7. Following a LOCA, low head recirculation flow was established on both RHR trains. Several hours later, debris blocks the suction lines from Containment Sump B to both trains of RHR and both RHR pumps are cavitating. The RO suggests making a transition to procedure ECA-1.1, "Loss of Emergency Coolant Recirculation"

Recommend key be modified to accept B or C vice A for SRO Question 7.

FIGURE ECA11-1. MINIMUM INJECTION FLOW RATE VERSUS TIME AFTER TRIP

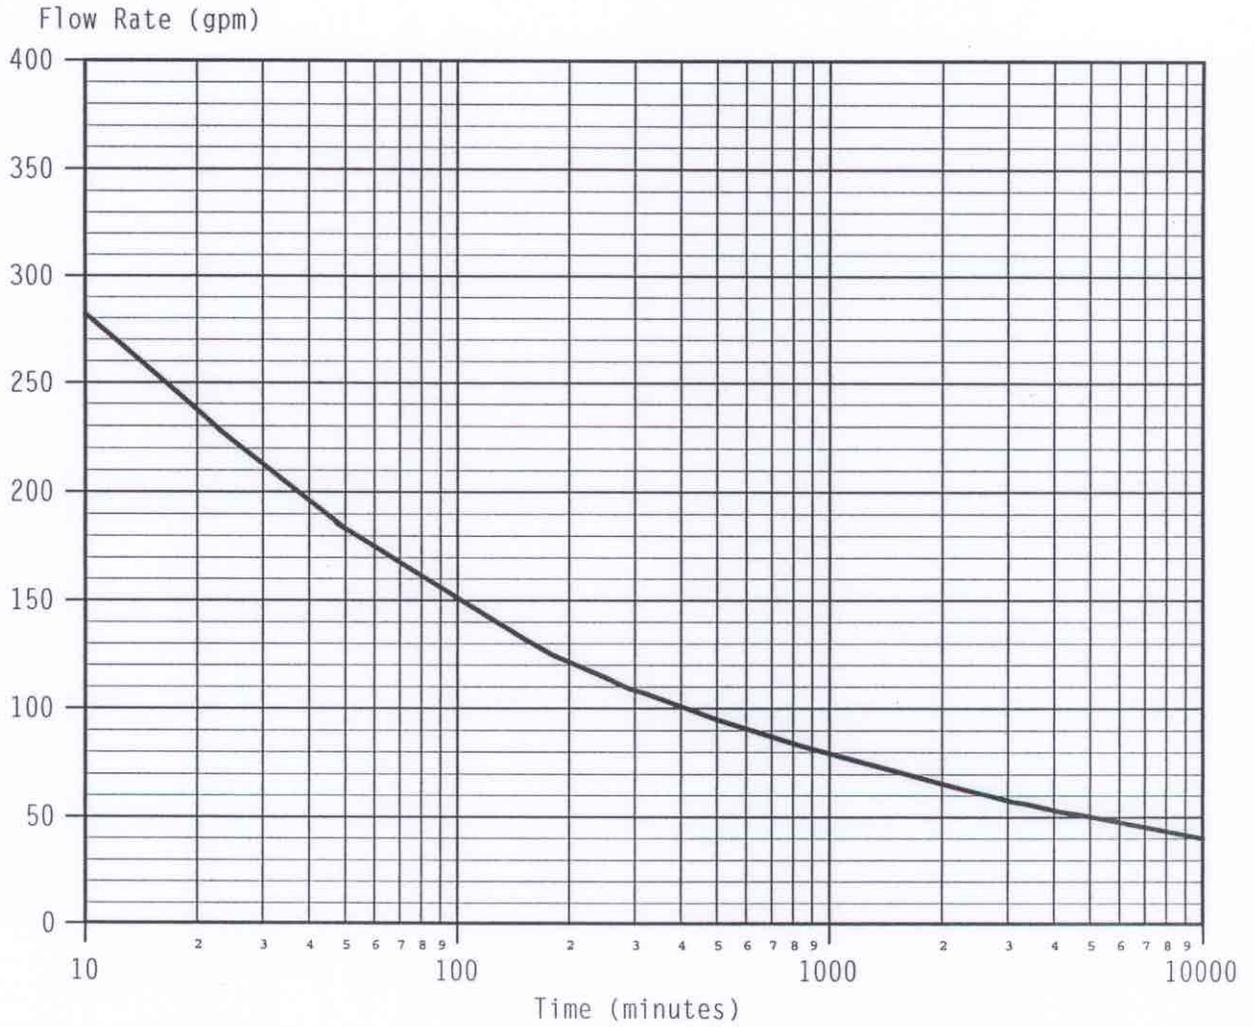
1. In step 10, one RHR pump would be stopped. This would reduce the pressure loss due to the blockage and increase the NPSH for the running RHR pump. This could restore both long-term and short-term core cooling.
2. In step 13-RNO, the total injection flow could be reduced to the minimum for decay heat removal which would reduce the pressure loss due to the blockage and increase the NPSH for the running RHR pump. This could restore both long-term and short-term core cooling.
3. In step 13-RNO b.2), charging is used to establish minimum injection flow.
4. In step 2, actions are performed to start filling the RWST. Combined with step 10, which starts an SI pump, these two steps would restore short-term cooling.
